TITLE:- 3LEAF RIGHT SIDE CRM DOOR 03/Gate 11

CLIENT - LESTECH
LOCATION - POSCO MANGAON
PRODUCT - SLIDING DOOR
If any queries contact : design@nihva.com
DWG NO:-NIHVA/22-23/CLT/0015 REV- 1
ALL DIMENSION ARE IN mm
SCALE: NTS SCALE:-- 1:1 SHEET: 01 OF 01

Rev No.	Revision	Date	Revised By
00	Released drawing	29/04/2022	Sujata
1.	Revised as per Client Comments	02/05/2022	Sujata

Client scope

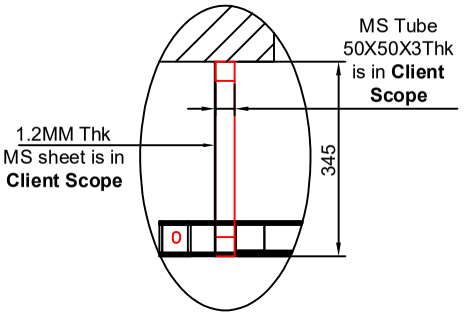
* Drainage area or pipe need to be shift from right side
*Roof need to be shift at top 365mm
*Gutter need to be close till pipe
